CUYAMA BASIN GROUNDWATER SUSTAINABILITY AGENCY STANDING ADVISORY COMMITTEE

AGENDA

November 29, 2018

Groundwater Sustainability Plan Update

Figure 2.2-24:2011-2018 Average Well Measurements of Total Dissolved Solids, mg/L
 Cuyama Basin Groundwater Sustainability Agency
 Cuyama Valley Groundwater Basin Groundwater Sustainability Plan
 August 2018

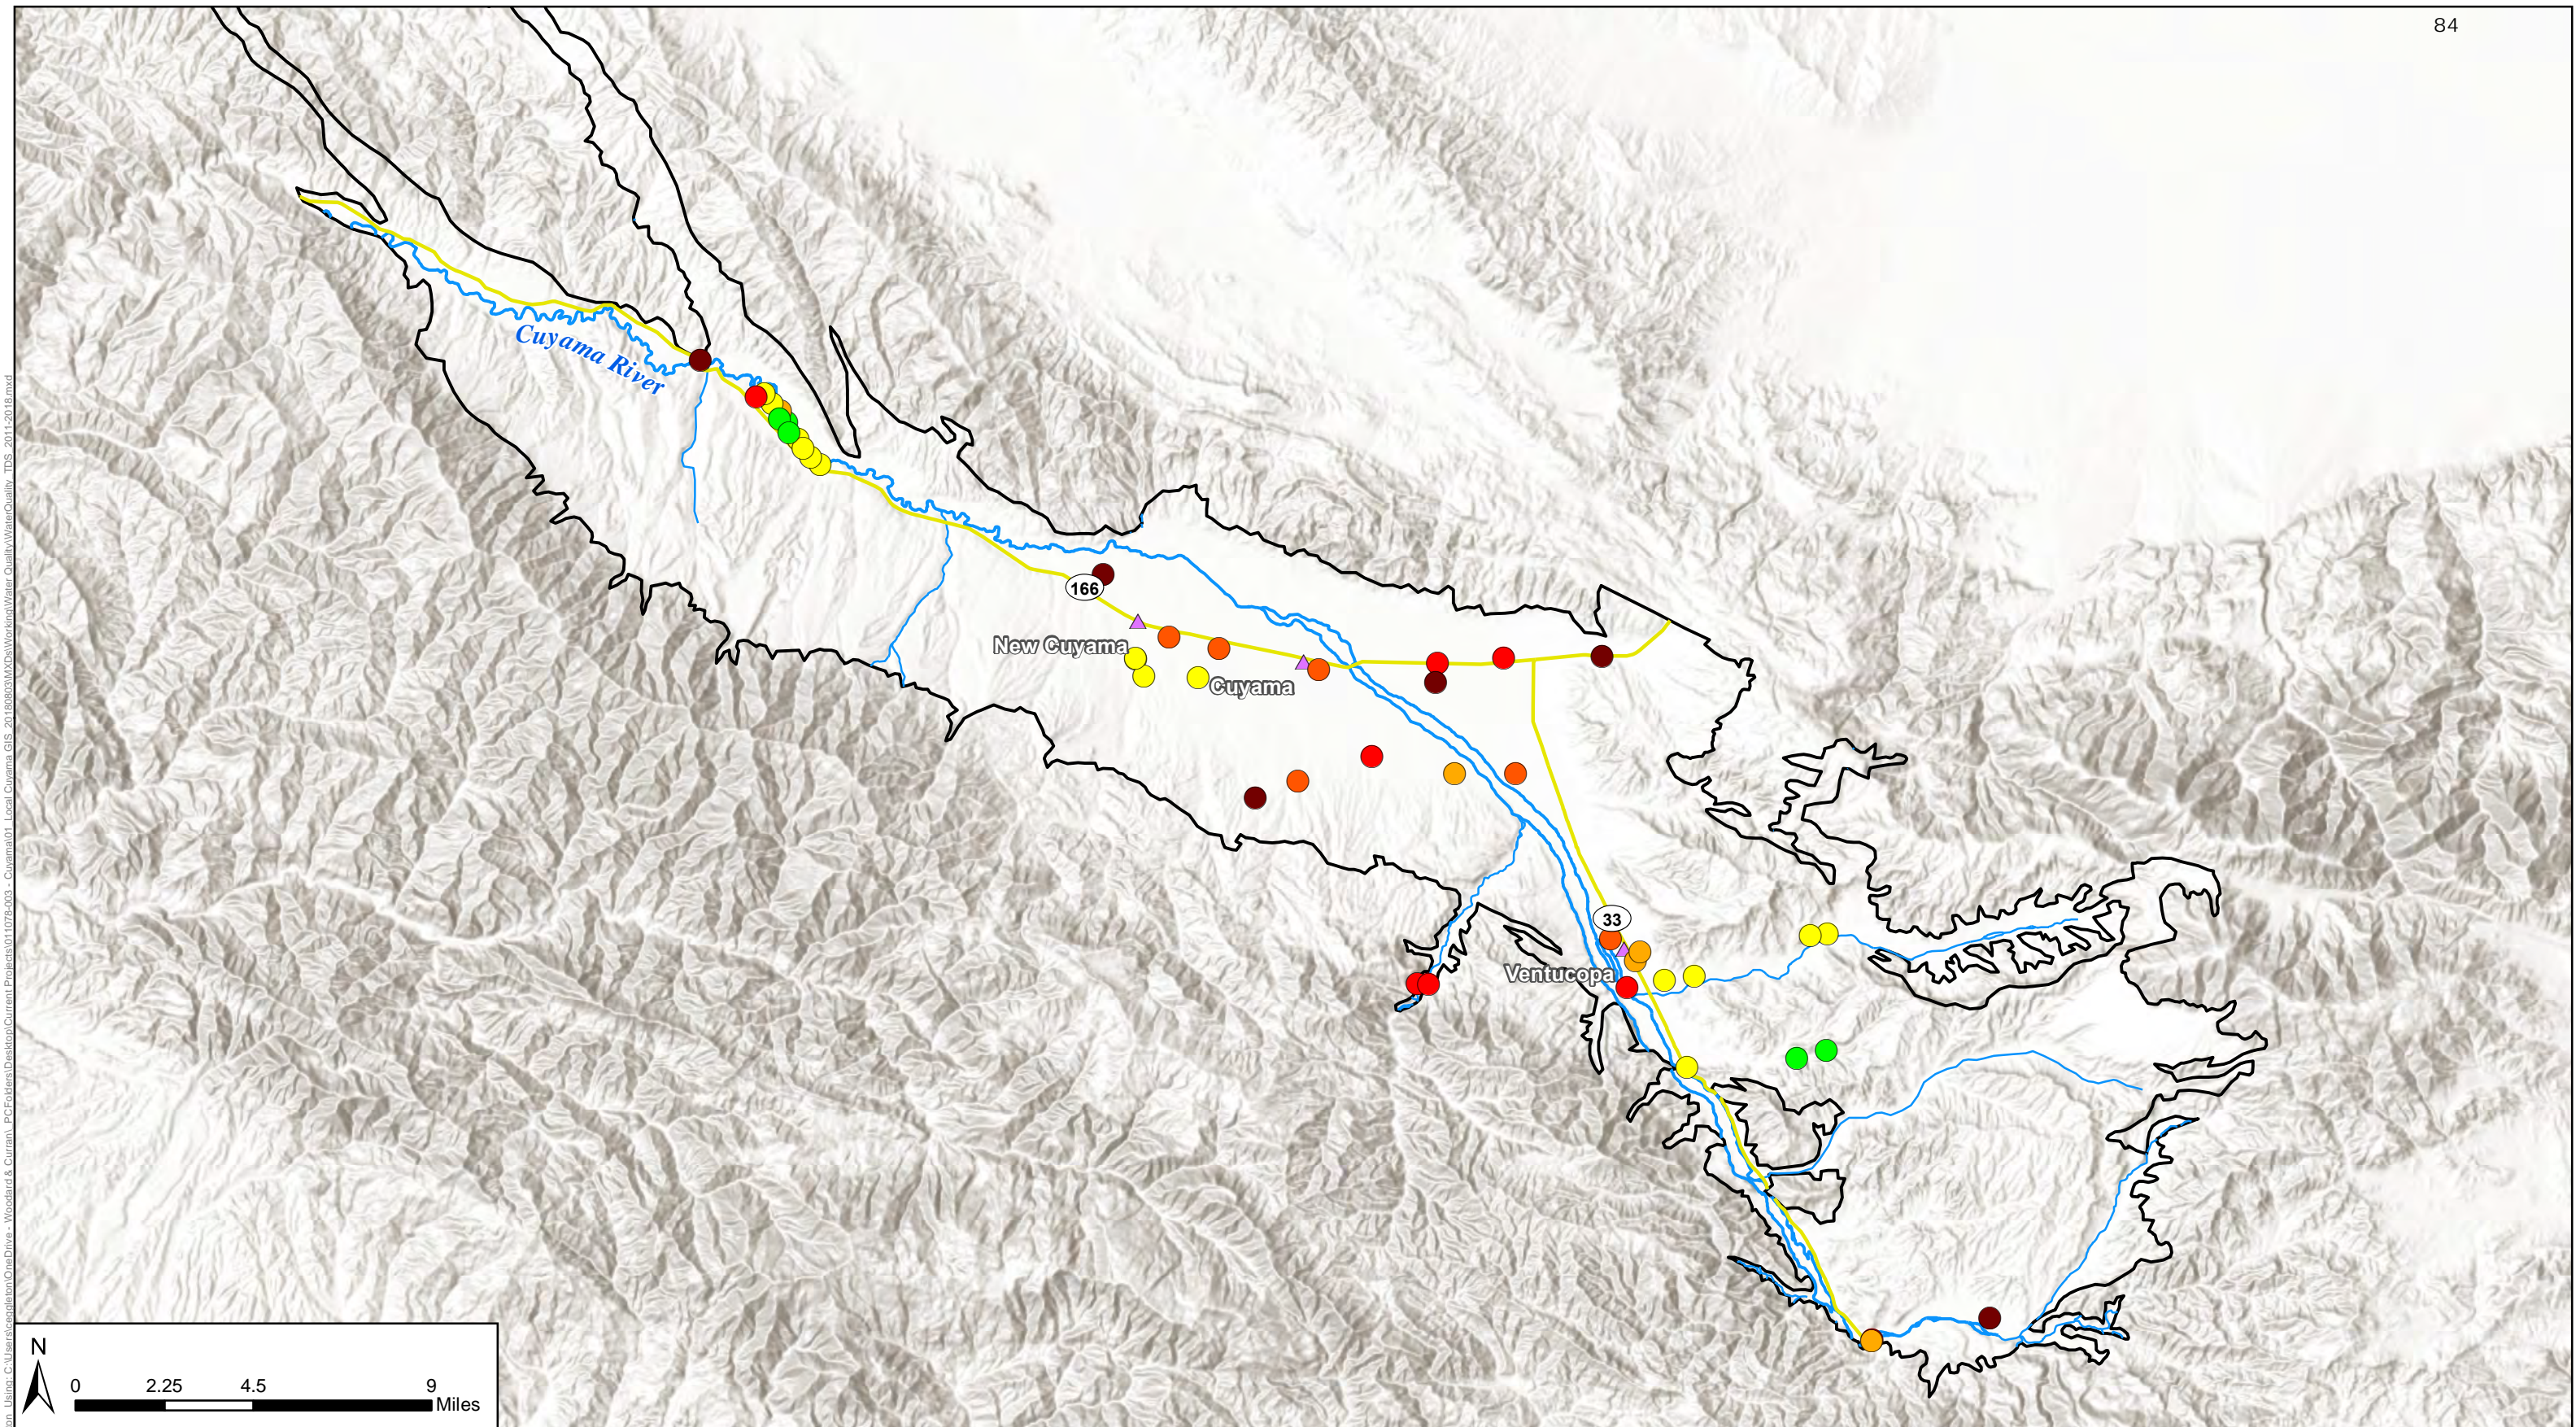
102	Cathy Martin	County of San Luis Obispo	Figure 2.2-24	N/A	N/A		Place label on figure (Quatal Canyon, and along the Cuyama River between Cottonwood Canyon and Schoolhouse Canyon)	These are labeled on Figure 2.2-1
103	Cathy Martin	County of San Luis Obispo	Figure 2.2-25	N/A	N/A		Place label on figure (Quatal Canyon)	This is labeled on Figure 2.2-1

Figure 2.2-25: Cuyama Groundwater Basin Historic TDS Levels in Selected Wells
 Cuyama Basin Groundwater Sustainability Agency
 Cuyama Valley Groundwater Basin Groundwater Sustainability Plan
 August 2018

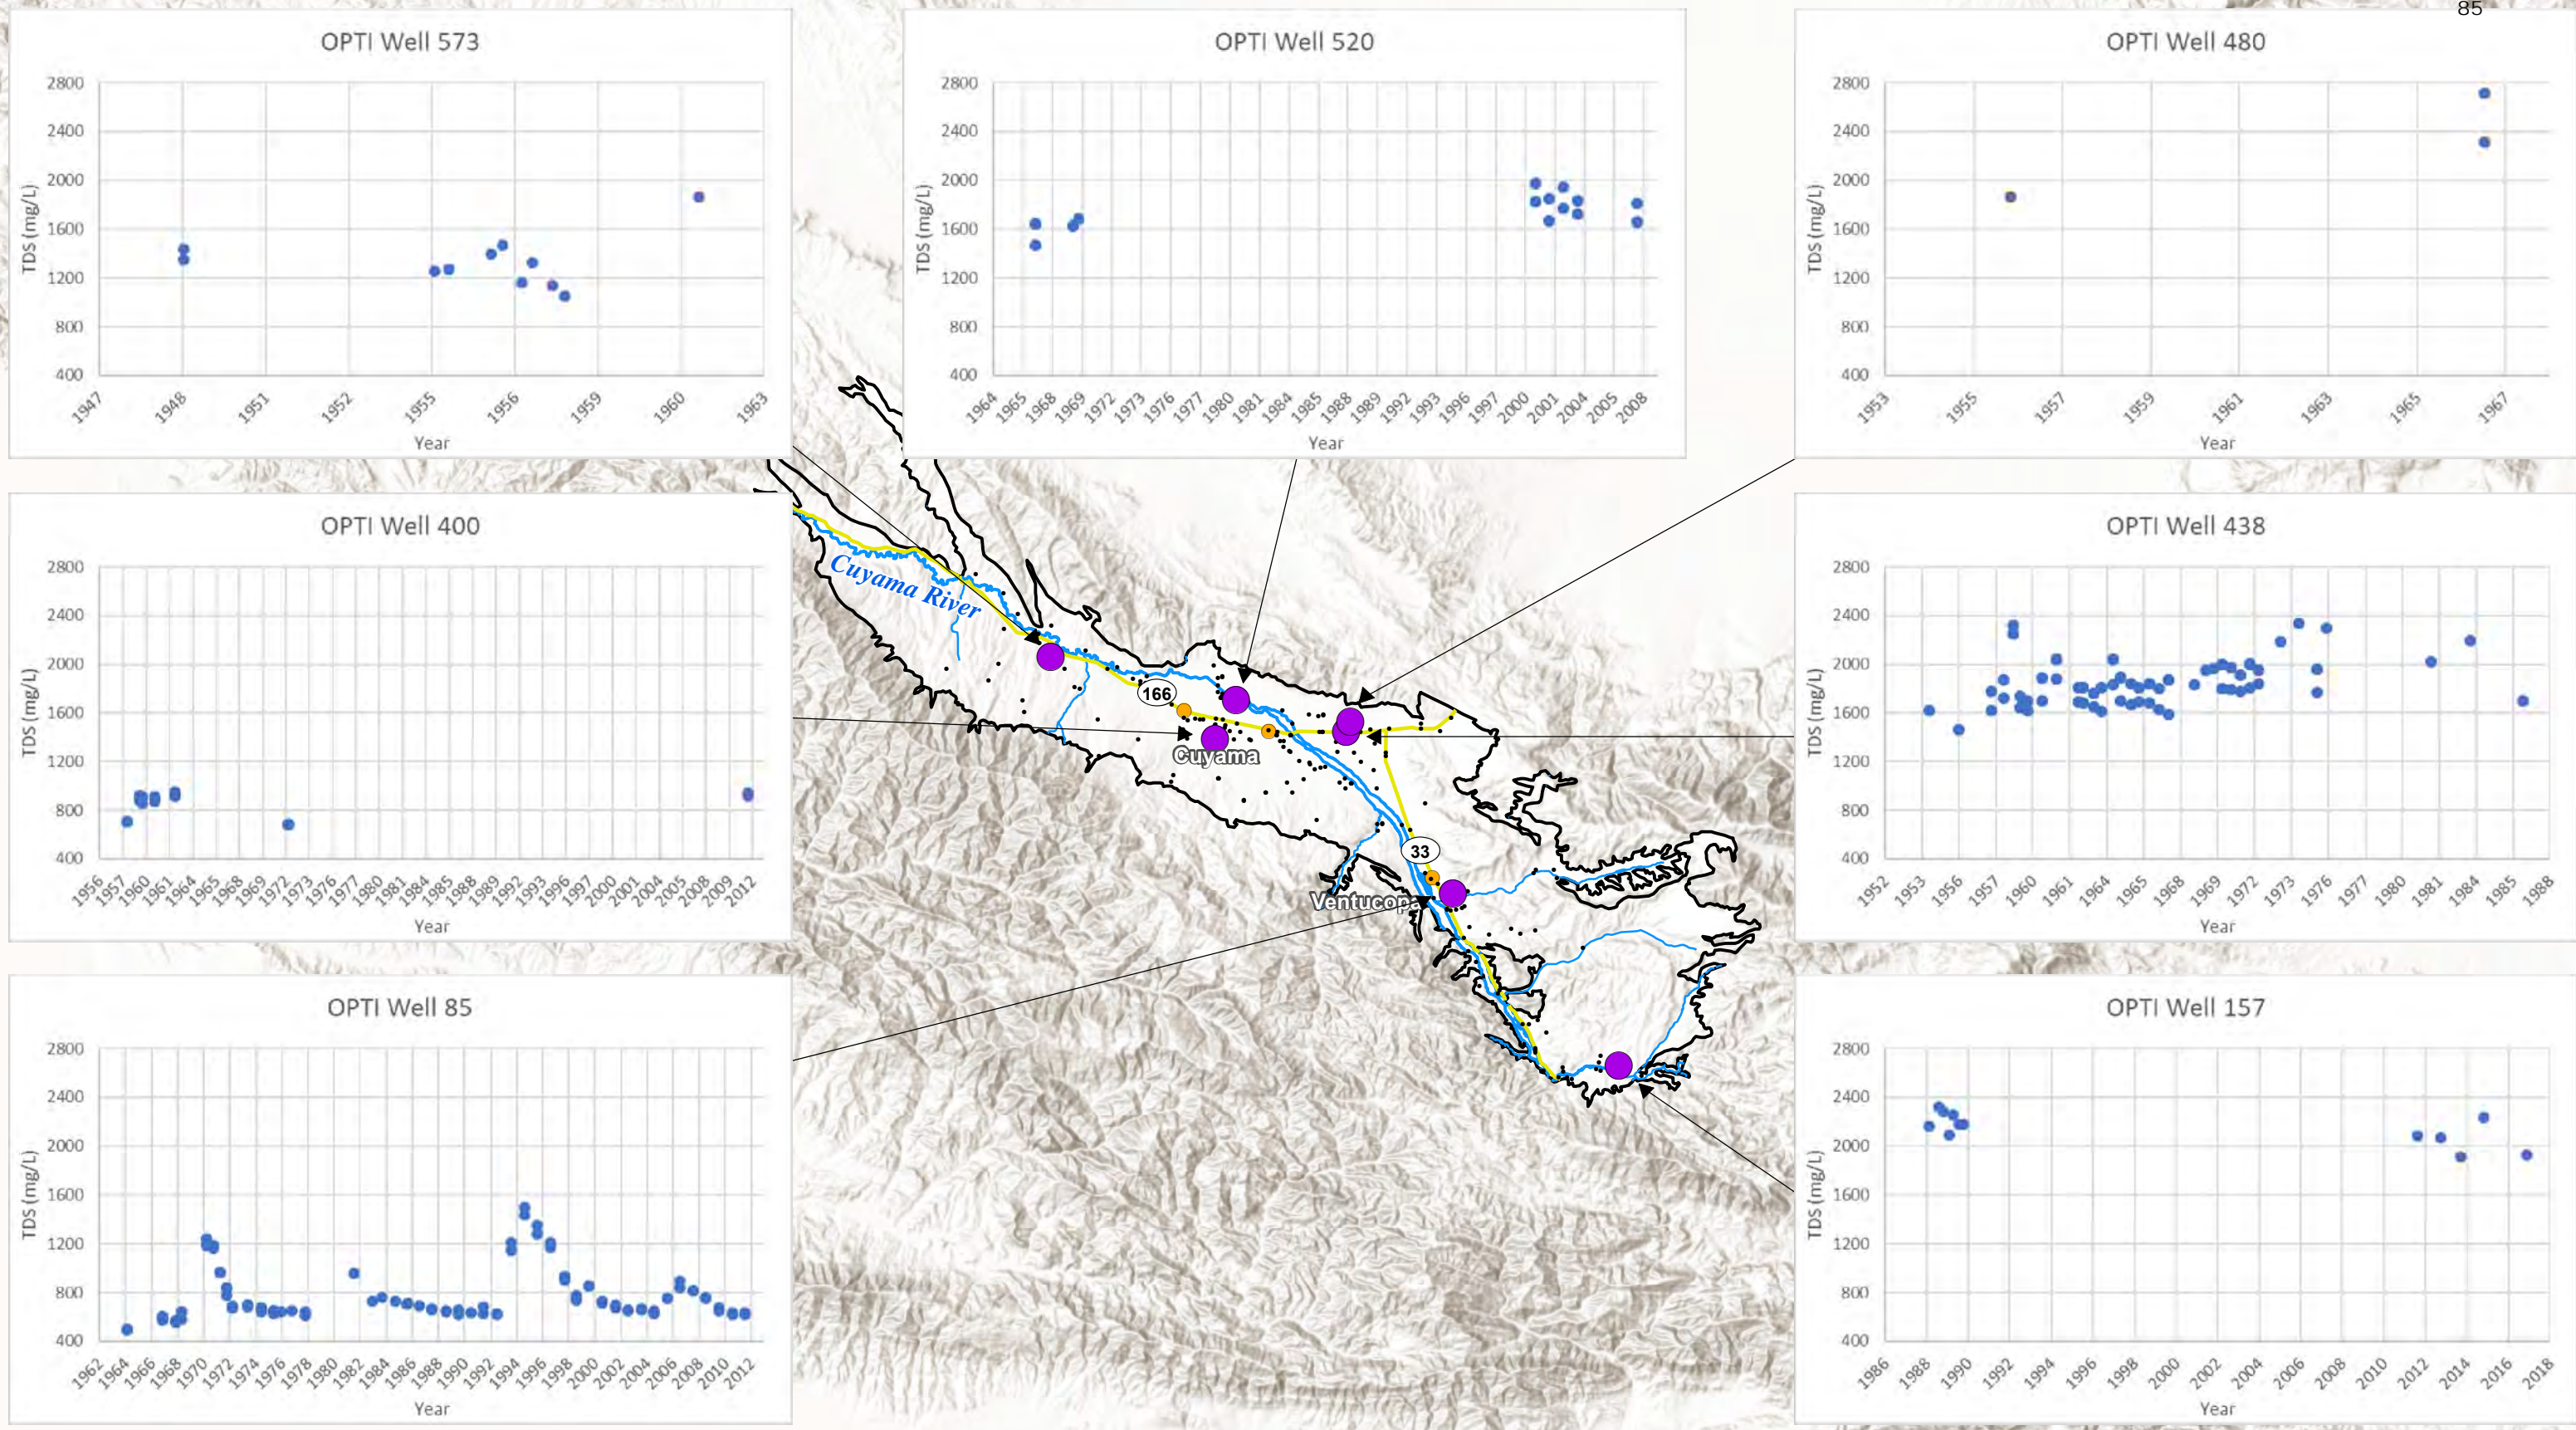
176	Matt Young, Matt Scudato, & Fray Crease	Santa Barbara County Water Agency	Figure 2.2-25				Include a line showing the MCL on the figure	MCL lines have been added to the figure.
177	Matt Young, Matt Scudato, & Fray Crease	Santa Barbara County Water Agency	2.2.7 Data Analysis			Figure 2.2 28 shows arsenic measurements	USGS data indicate 4 of the 33 wells were >10 Only 25 wells used in this study. Why the discrepancy and why were the 4 wells with >10 not used? Please elaborate on data selection used for this analysis.	The text and figure have been reviewed and updated.
178	Matt Young, Matt Scudato, & Fray Crease	Santa Barbara County Water Agency	2.2.7 Data Analysis			Figure 2.2-28 shows arsenic measurements	What about the CSD? They treat for arsenic.	The CSD did not provide any arsenic data.
179	Matt Young, Matt Scudato, & Fray Crease	Santa Barbara County Water Agency	2.2.7 Data Analysis			Figure 2.2-29 shows that most of these sites	Describe for the reader what this means – leaks from storage tanks?	The text has been revised for clarity.
